## SERVICE LETTER 112

### OPTIONAL HYDRAULIC POWER PACK TIMER RELAY INSTALLATION

<b>Aircraft Makes/Model(s):</b>	<b>Float Model(s):</b>	<b>Compliance:</b> Recommended	<b>By:</b> MAS
Aviat Husky, Cessna 170, 172, 175, 180, 182, 185, 206, 208, 208B Piper PA-18, PA-12, American Champion 8GCBC, Pilatus PC-6, DeHavilland DHC-2, DHC-3, Quest Kodiak 100	2100A, 2350A, 3000A, 3450A, 6100A, 7000A, 8000A, 8750A	<b>Part Number:</b> 1005052	<b>Approved:</b> DRH
		<b>Date:</b> 10/10/2024	<b>Revision:</b> H

**CONFIGURATION -01 SINGLE PUMP WIRING SCHEMATIC**  
 (RELAYS SHOWN IN RELAXED CONDITION)

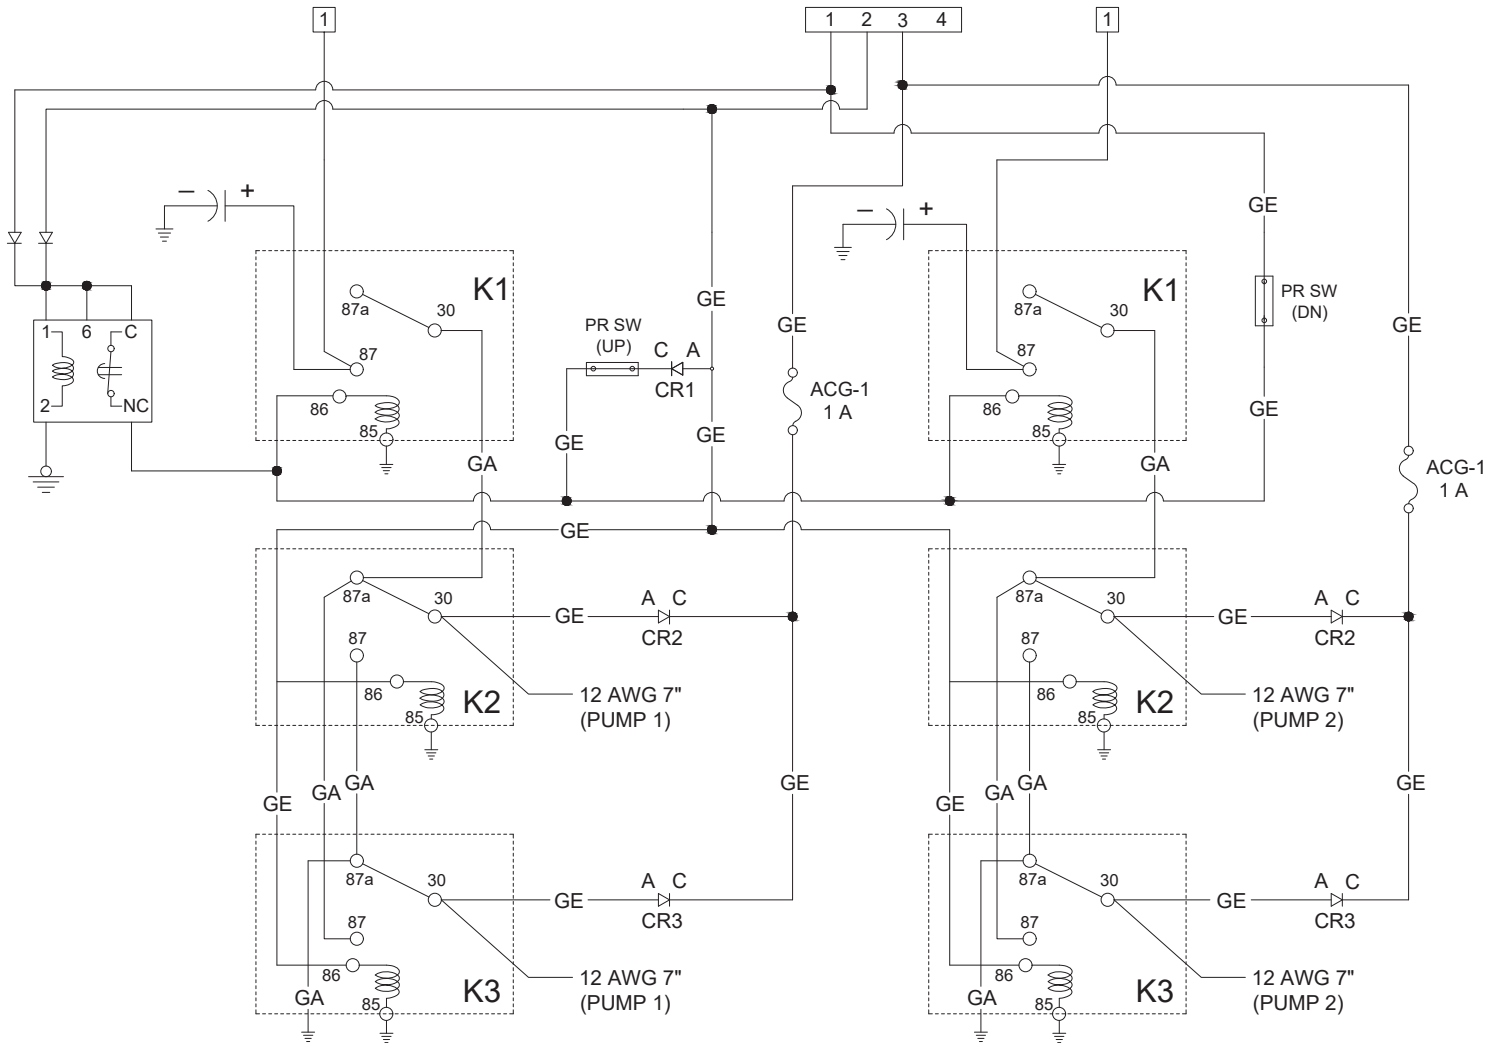
### 1005052-01 CONFIGURATION (BI-DIRECTIONAL PUMPS EXCLUDING DHC-2) INSTALLATION

2. Remove backshell from three-wire round plug on pump side of connection.
  - a. Cut back heat shrink 1" from plug end.
  - b. Remove pin 1 from round connector.

- i. Cut off pin and strip insulation back on removed wire. Strip back insulation on one of the wires coming from terminal "1" of the time delay relay.

- ii. Using pin 66099-4, crimp both wires together in the pin. Install pin into round connector at position "1".
  - c. Remove pin 2 from round connector.

- i. Cut off pin and strip insulation back on removed wire. Strip back insulation on the other wire coming from terminal 1 of the time delay relay.

- ii. Using pin 66099-4, crimp both wires together in the pin. Install pin into round connector at position "2".
  - d. Reinstall backshell onto three-wire round plug.

3. Disconnect two wire molex plug on the down pressure switch. Down pressure switch is the pressure switched that is on the same side of the hydraulic manifold as the hydraulic fitting labeled "DN".

- a. Remove pin 1 from molex housing. Pin locations are marked on the bottom of the plug where the wires enter.
    - i. Cut off pin and strip insulation back on removed wire. Strip back insulation on the wire coming from "NC" terminal from the time delay relay assembly.

- ii. Using pin 02-09-1117, crimp both wires together in the pin. Install pin into molex housing at position "1".
4. Connect the wire from "2" terminal from the time delay relay to ground using MS25036-102 terminal ring.
